STATE OF CALIFORNIA **ACHSSTP-000C(365)E**
DEPARTMENT OF TRANSPORTATION
PROJECT PLANS FOR CONSTRUCTION ON
STATE HIGHWAY

IN PLACER COUNTY
AT VARIOUS LOCATIONS

1 REPLACED PER ADDENDUM No. 1
 DATED SEPTEMBER 27, 2013

CONTRACT No.	03-3f4104
PROJECT ID	0312000283

TRAFFIC HANDLING PLAN
LOCATION 1
SCALE: 1"=20'

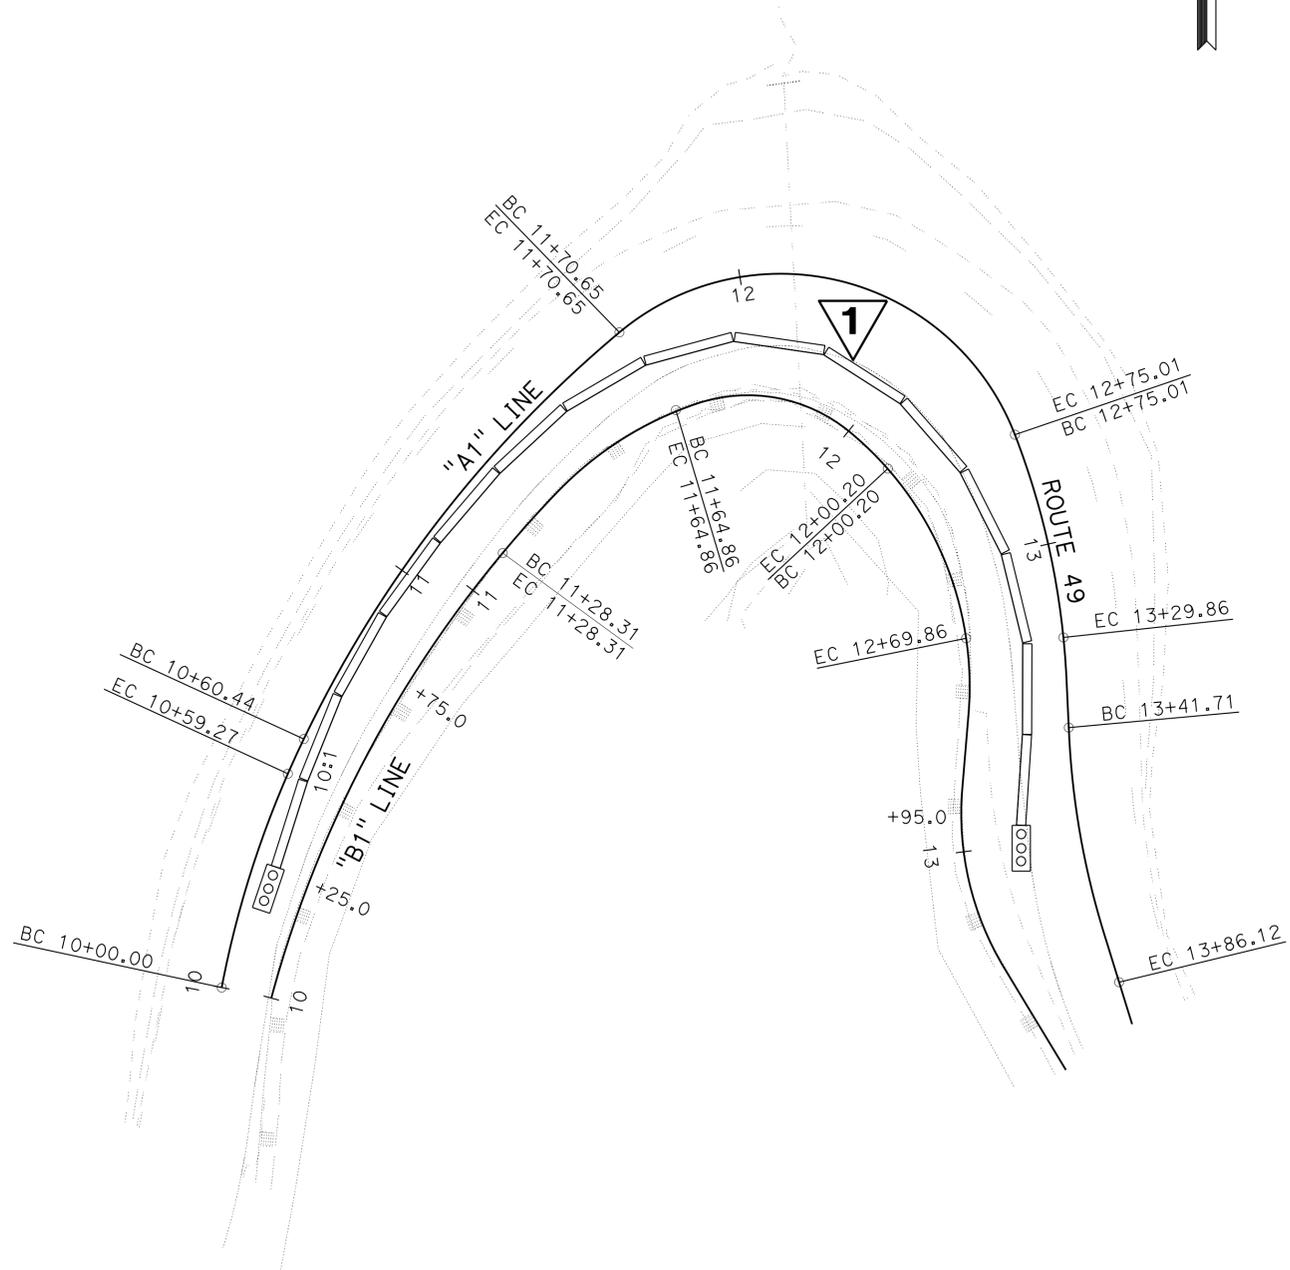
1. ~~40' SECTION~~ TEMPORARY K-RAILS TO BE INSTALLED 14' FROM "B1" LINE OR AS DETERMINED BY THE ENGINEER.
2. ALL SIGN CODES SHOWN ARE FEDERAL SIGN CODES UNLESS OTHERWISE DESIGNATED AS CALIFORNIA SIGN CODES.
3. ALL TRAFFIC PLASTIC DRUMS SHALL BE INSTALLED ON 50' CENTERS UNLESS OTHERWISE SHOWN.
